530-021-15

## ADDENDUM NO. 1

Concordia University -  
Nebraska  
Weller Hall Interior  
Improvements - Phase 3  
800 N. Columbia Ave.  
Seward, Nebraska

**1 INTERIOR ELEVATION (NORTH CHAPEL WALL)**  
SCALE: 1/4"=1'-0"

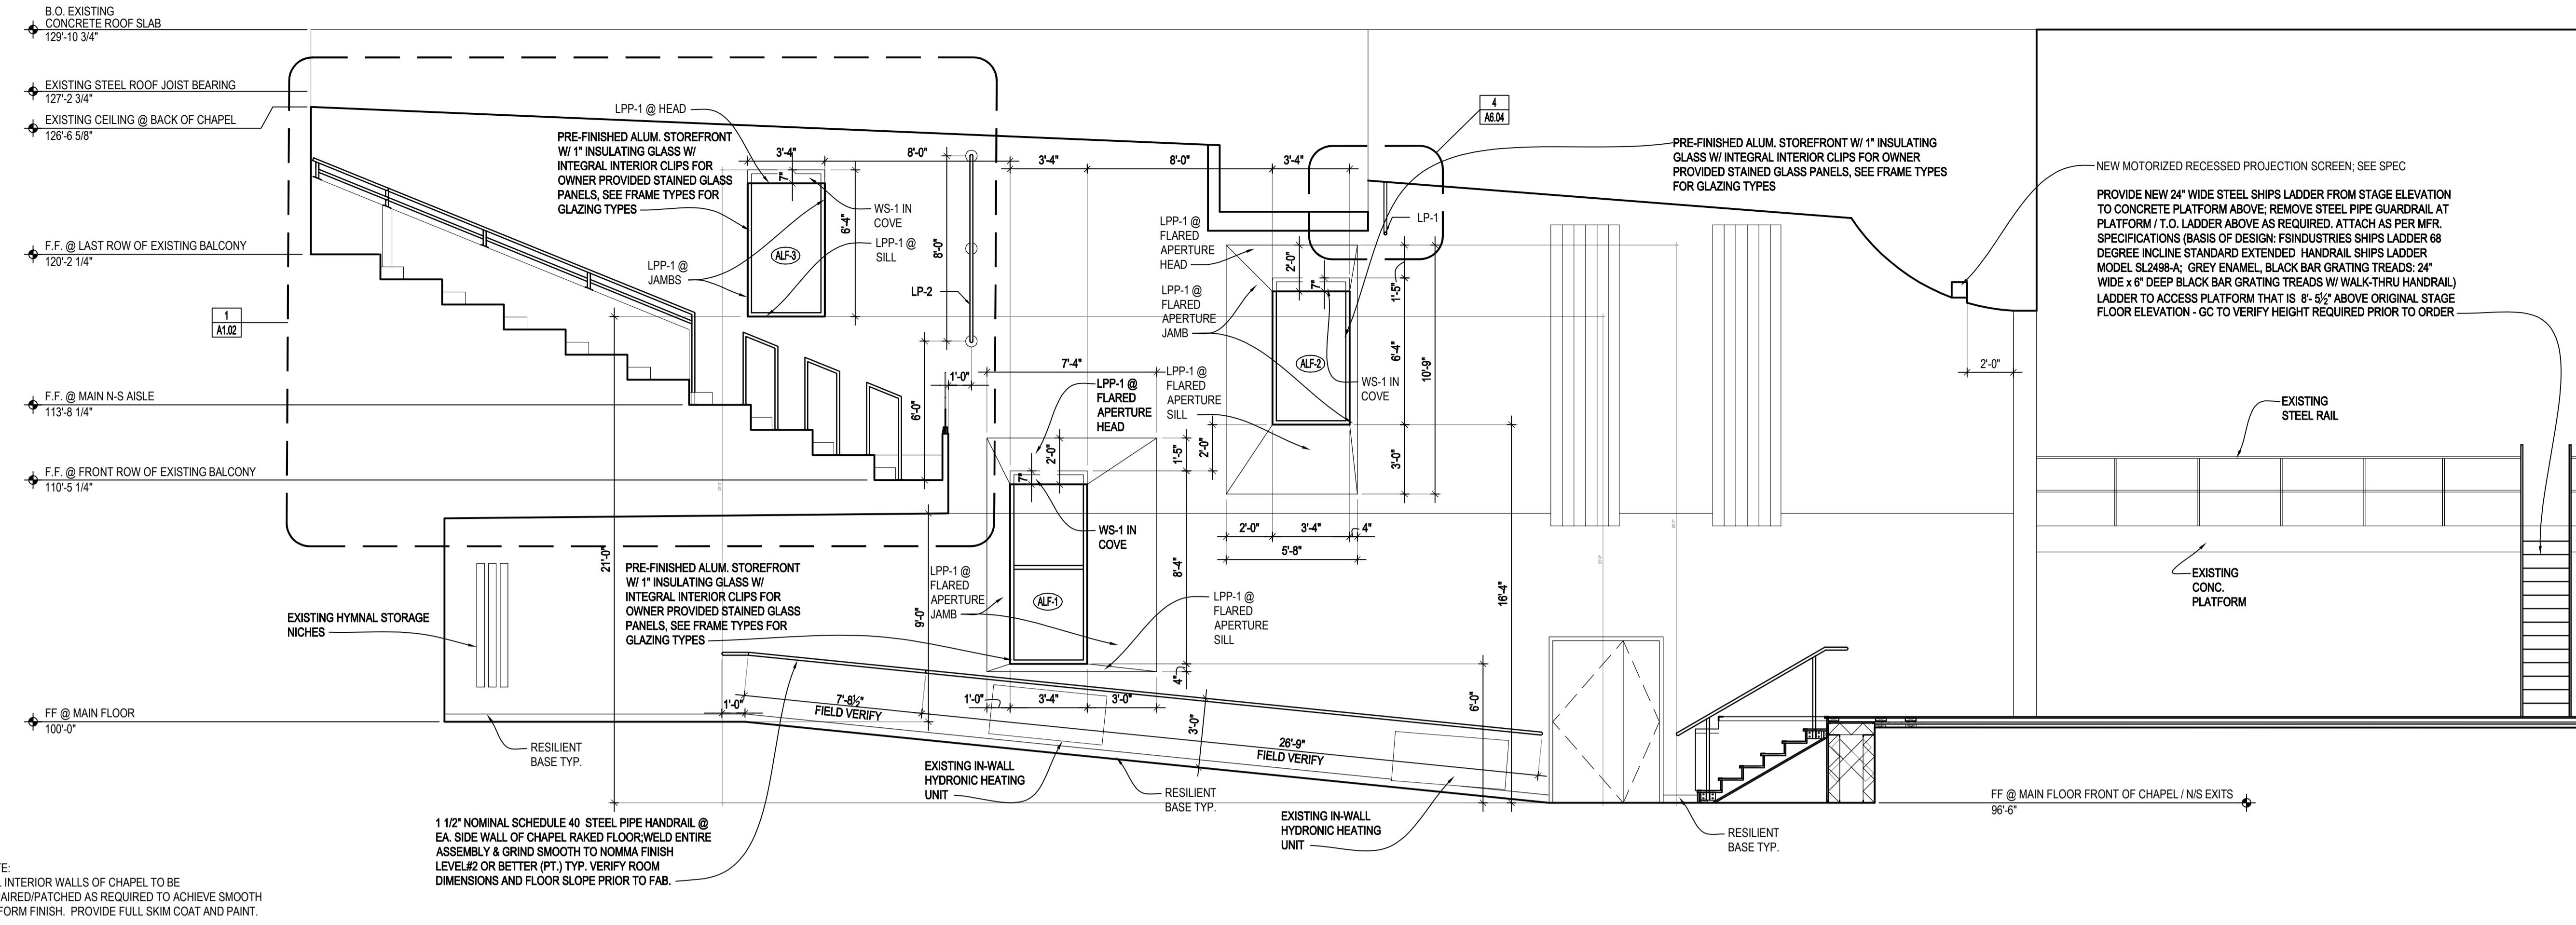
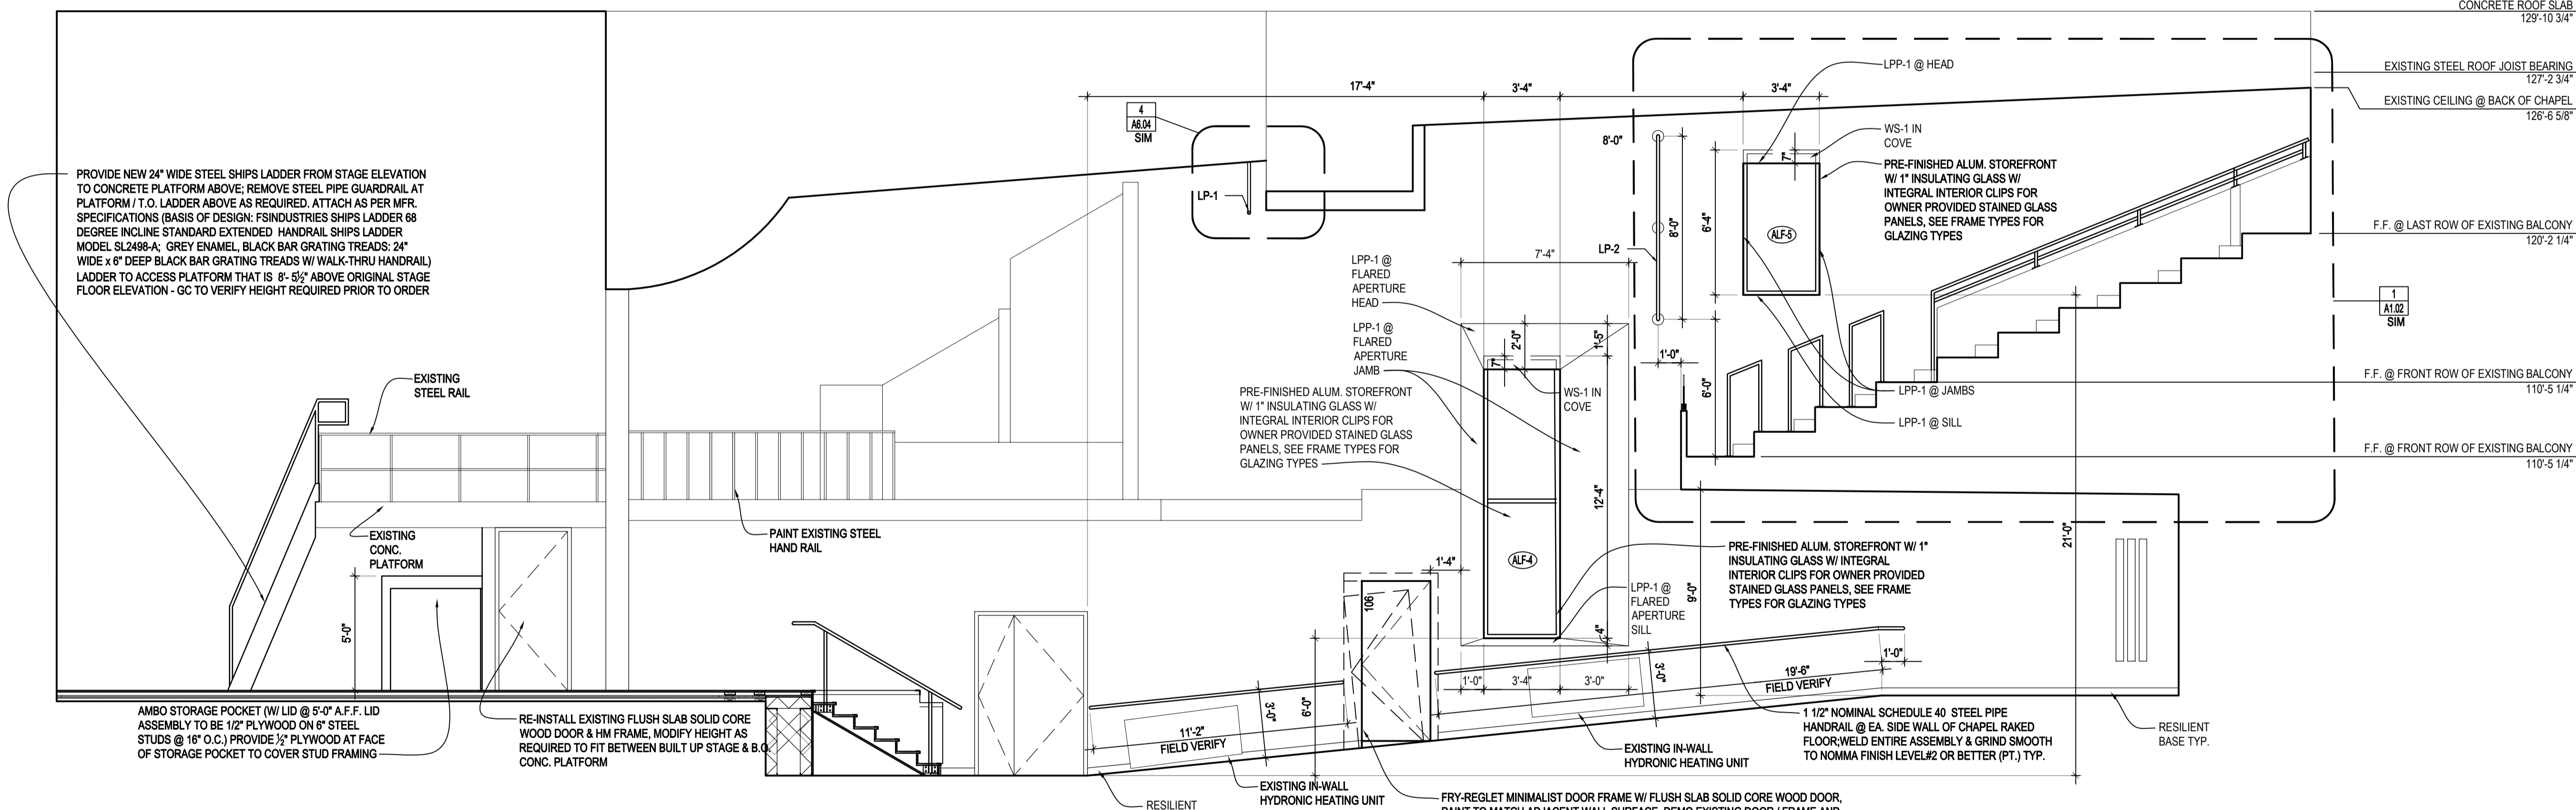
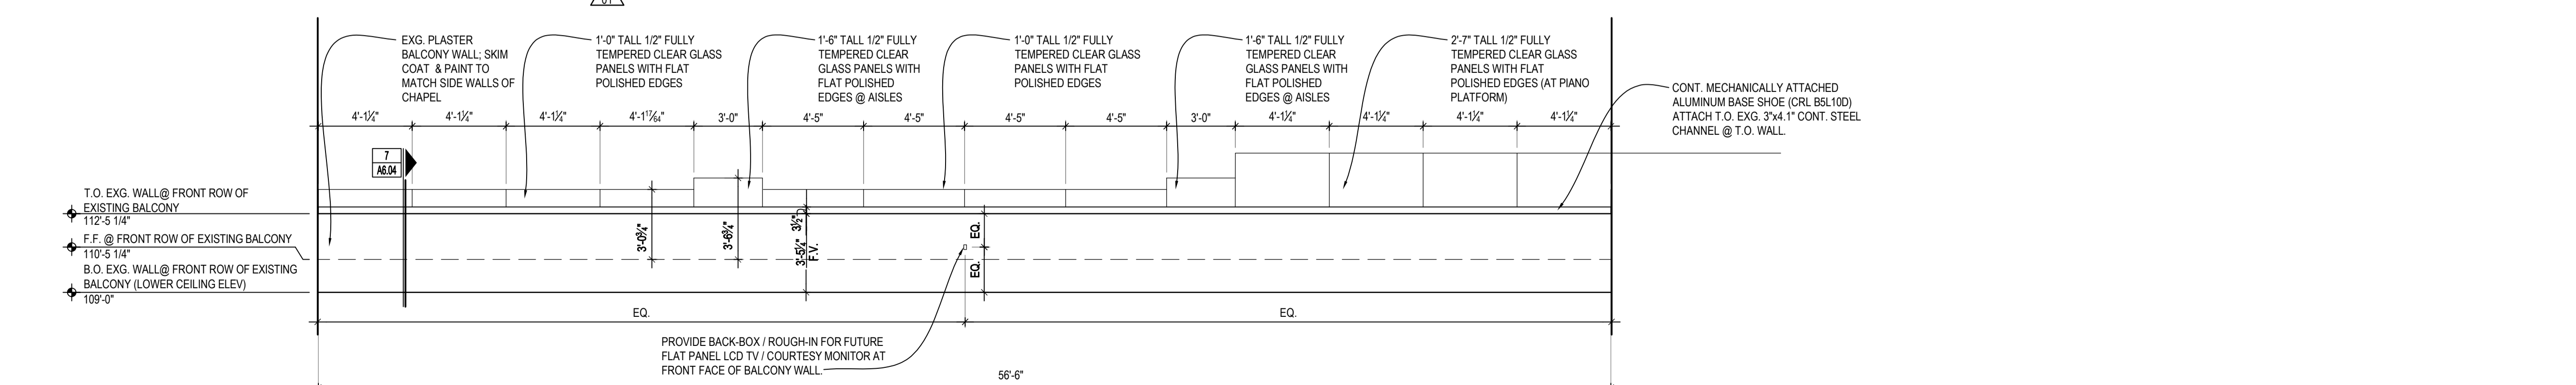
Sheet reissued in its entirety. - Refer to North and South Chapel Interior Elevations (notes indicating LPP-1 locations, revised ALF sizes / locations, WS-1 locations)

**1 EXTERIOR ALUMINUM FRAME TYPES**

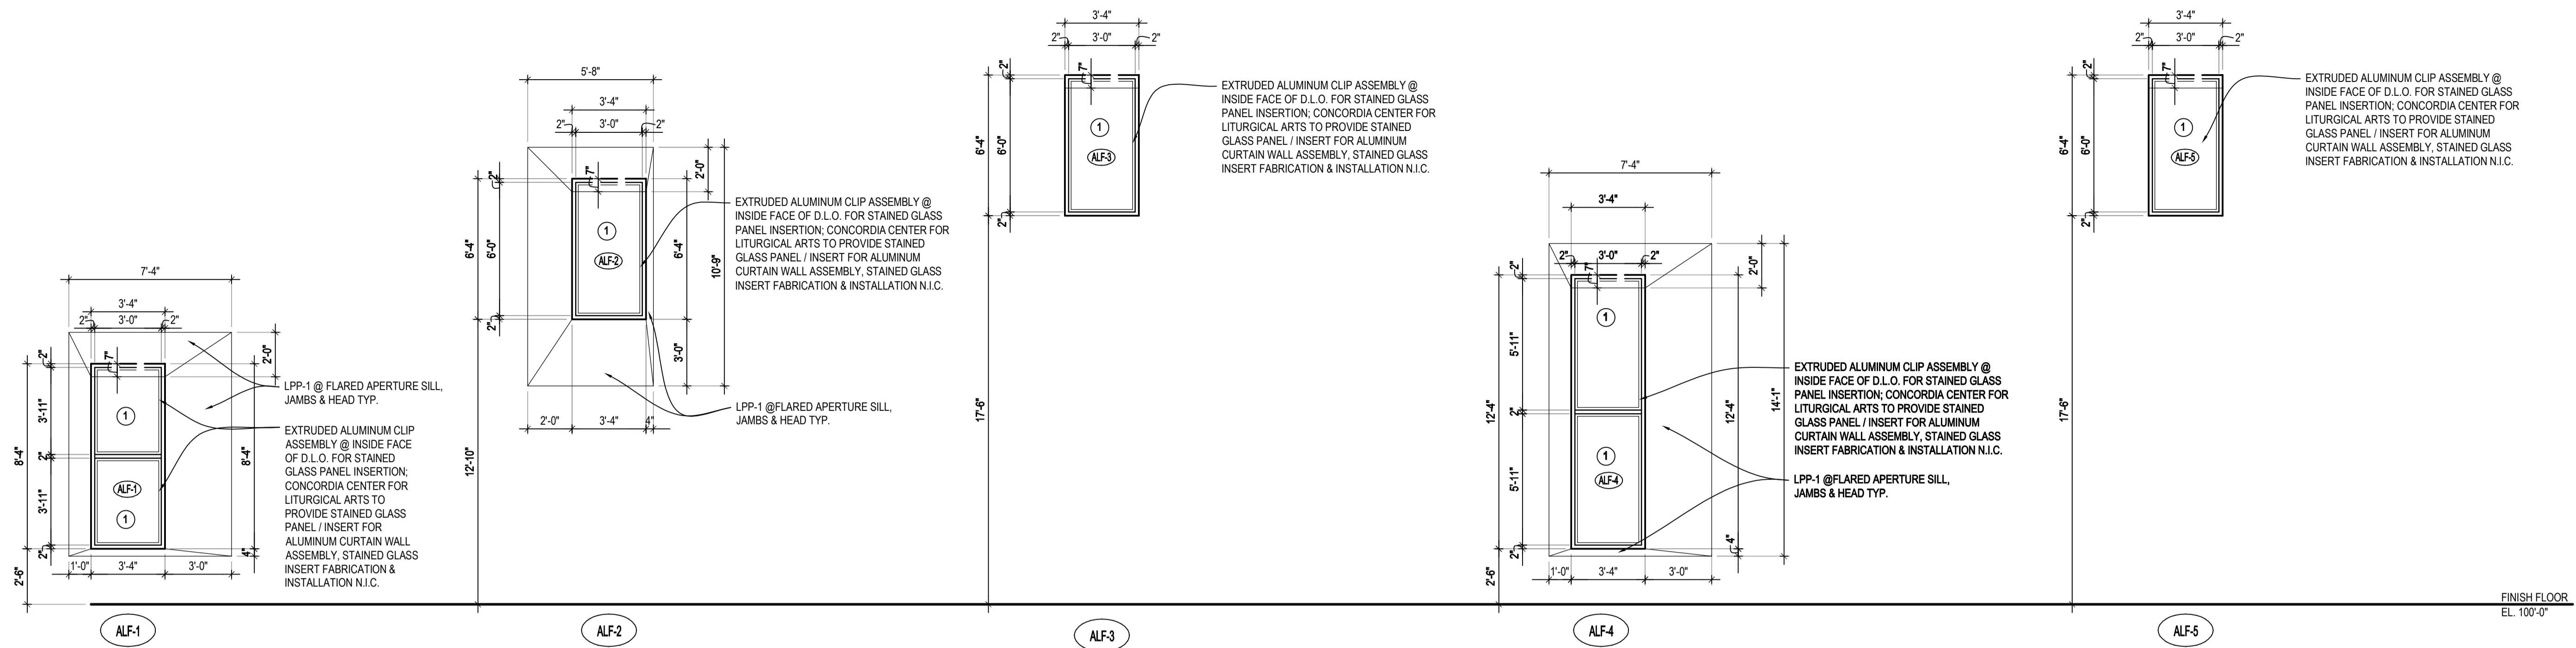
Sheet reissued in its entirety. - Exterior Aluminum Frame Types (revised sizes & elevations).

**1 ENLARGED STAGE PLAN**  
 SCALE: 1/4"=1'-0"

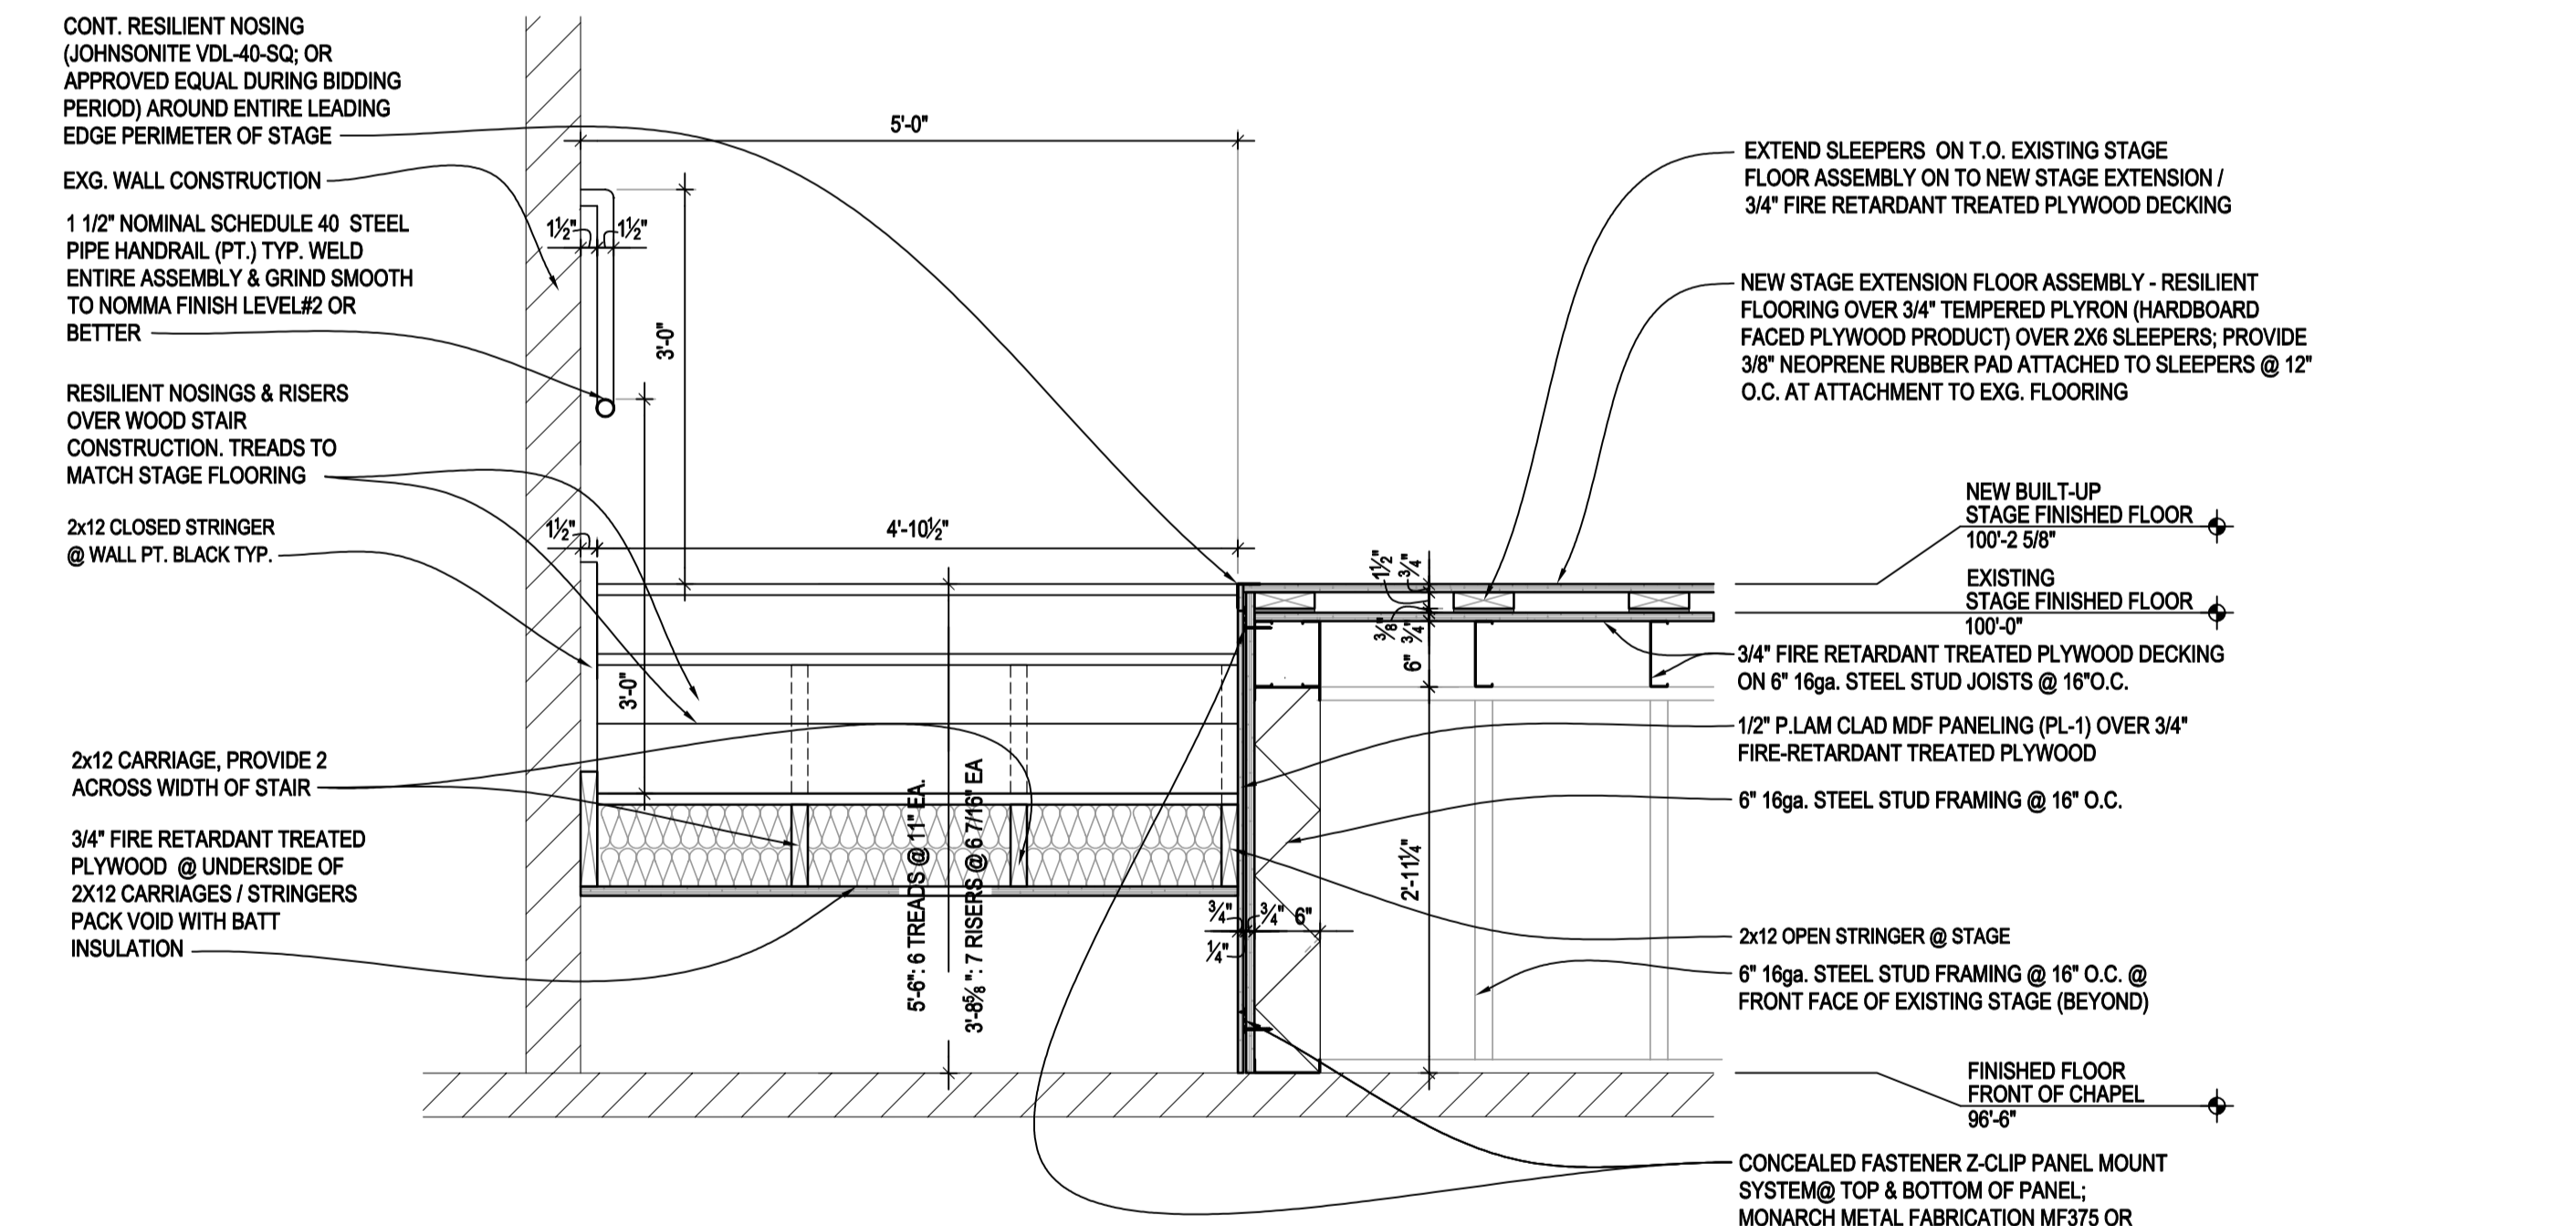
Refer to Enlarged Stage Plan: The two return air grilles indicated to be removed are not located in the stage floor. The grilles are existing return air grilles on the front face of the existing stage front wall @ the return air duct openings.
